January 25, 2005

Monica T. English, Environmental Specialist  
Alaska Dept. of Environmental Conservation  
Division of Spill Prevention and Response CSP  
43335 Kalifornsky Beach Rd, Suite 11.

Subject: **Corrective Action Plan, Spill #01-23-00-337-01  
Chinook Tesoro, Mile 136.5 Sterling Highway, Ninilchik, AK**

<p>ROZAK ENGINEERING PO BOX 350 KENAI, AK</p> <p>Drawn by: EH 06.17.02 Rev. by: <u>RTR 1.24.05</u></p>	<p><b>Proposed Corrective Action Plan</b> <b>Chinook Tesoro</b> <b>Ninilchik, Alaska</b></p> <p style="text-align: right;"><i>Figure 1</i></p>
--	--

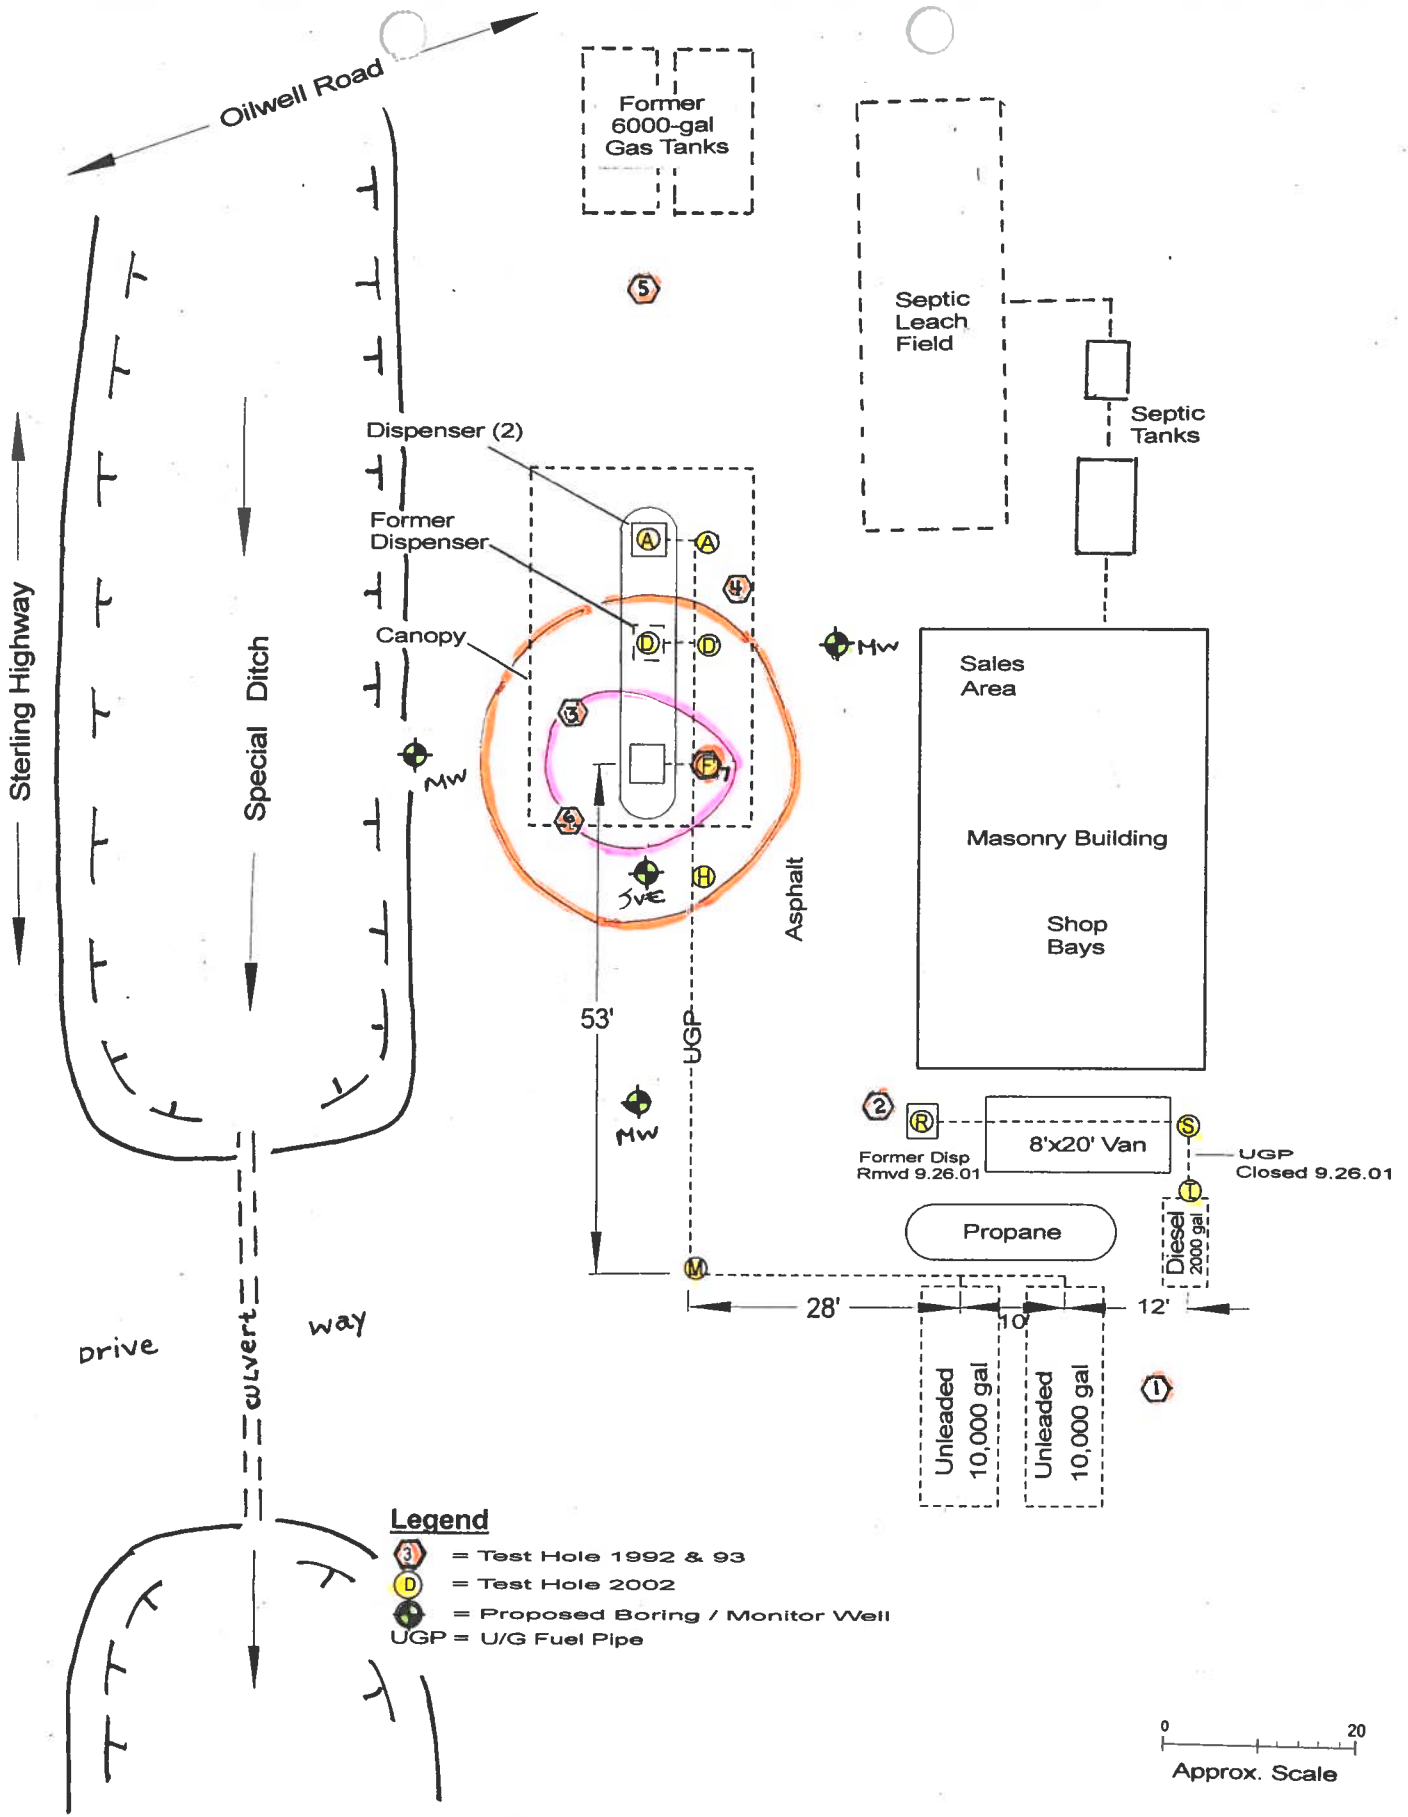
are soils  
conducive to  
remediation? Appears  
to be tight soils (ie  
silt)

anticipated SWL depth? previously drilled 0-20' bgs will drill to GW per phone conversation w/ Ron Rozak on 3-9-05

Ron will include a KPB satellite map of surrounding area (including west side of Sterling Hwy)
